SUBJECT: EPRI TOPICAL REPORT (TR) 104965, "ON-LINE MONITORING OF
INSTRUMENT CHANNEL PERFORMANCE," FINAL REPORT, NOVEMBER 1998
(TAC NO. M93653)

SAFETY EVALUATION BY THE OFFICE OF NUCLEAR REACTOR REGULATION

EPRI TOPICAL REPORT (TR) 104965

"ON-LINE MONITORING OF INSTRUMENT CHANNEL PERFORMANCE"

Figure: Deviation Zones for Acceptance Criteria

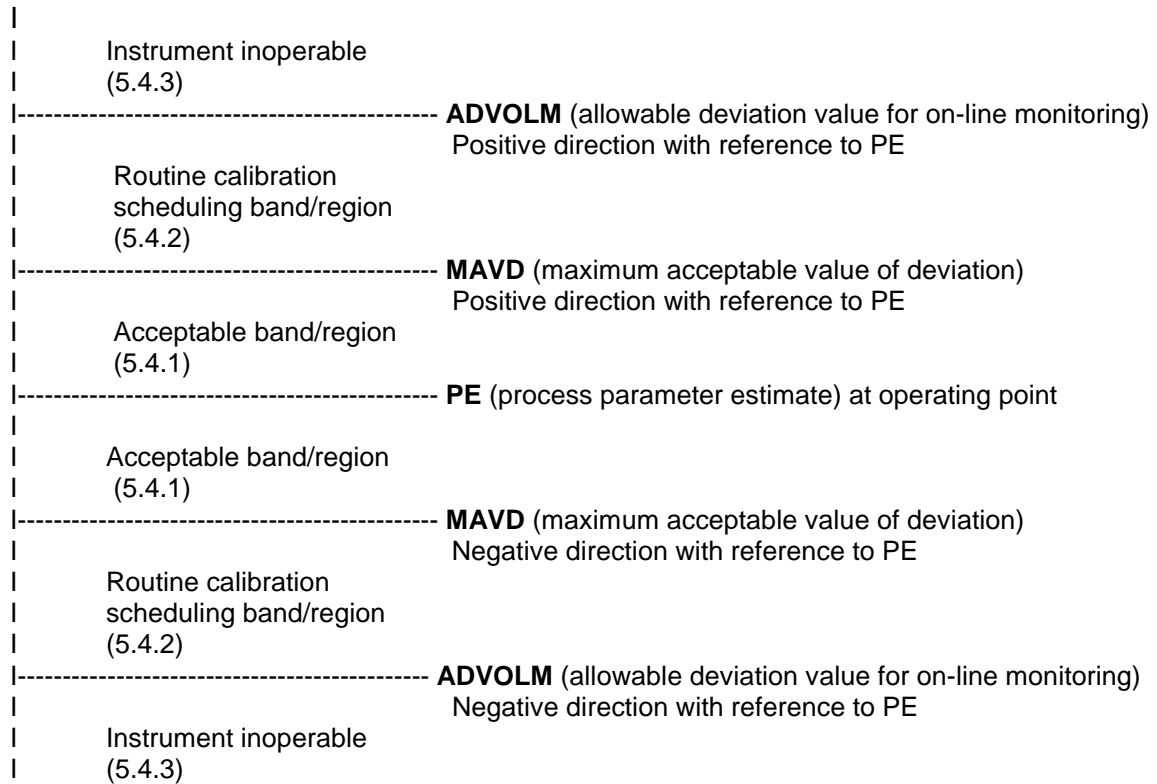
Each channel's deviation from its PE represents its variation from the estimated value of the process. The amount of this variation is compared with preestablished "acceptance criteria" and the instrument performance and its operability status are determined in accordance with three bands described in Sections 5.4.1, 5.4.2 and 5.4.3, and the figure, Deviation Zones for Acceptance Criteria. The acceptance criteria are established by calculating acceptable limits of deviation in these three bands. It is possible that, due to changes in error factors (e.g., test equipment uncertainty, AL tolerance) implementing on-line monitoring may require revisiting the current TSP and uncertainty calculations. The staff requires that:

Calculations for the acceptance criteria defining the proposed three zones of deviation ("acceptable," "needs calibration," and "inoperable") should be done in a manner consistent with the plant-specific safety-related instrumentation setpoint methodology so that using on-line monitoring technique to monitor instrument performance and extend its calibration interval will not invalidate the setpoint calculation assumptions and the safety analysis assumptions. If new or different uncertainties require the recalculation of instrument trip setpoints, it should be demonstrated that relevant safety analyses are unaffected. The licensee should have a documented methodology for calculating acceptance criteria that are compatible with the practice described in Regulatory Guide 1.105 and the methodology described in acceptable industry standards for TSP and uncertainty calculations. (Requirement 5)
